Non-conformities and their consequences

M. Giovannozzi

- **Non-conformities for sector 5-6**
- **Non-conformities for sector 4-5**
- **Follow up of powering strategies during hardware commissioning**

Electrical Layout v.6.501

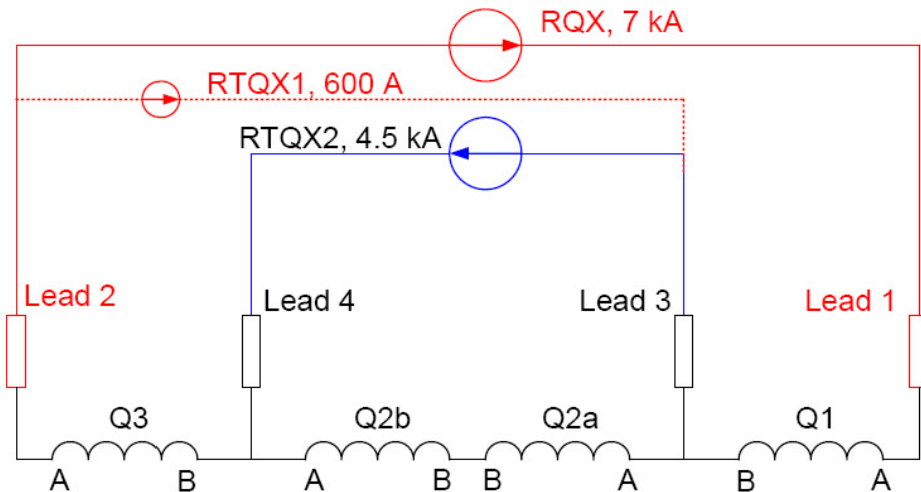
- Two main issues:
 - MCBCV10.L6.B1 (comments by A. Siemko): problem with its protection. One voltage tap is lost. Some extra tests should be performed to assess whether:
 - Repairing action possible
 - Limit current
 - Triplet quadrupoles (and correctors) polarity error (comments by S. Russenschuck): known and systematic error (e.g., MQSX). Only solution is to change the polarity at the level of the patch panel. Presentation at the MPP given (14/04/08).
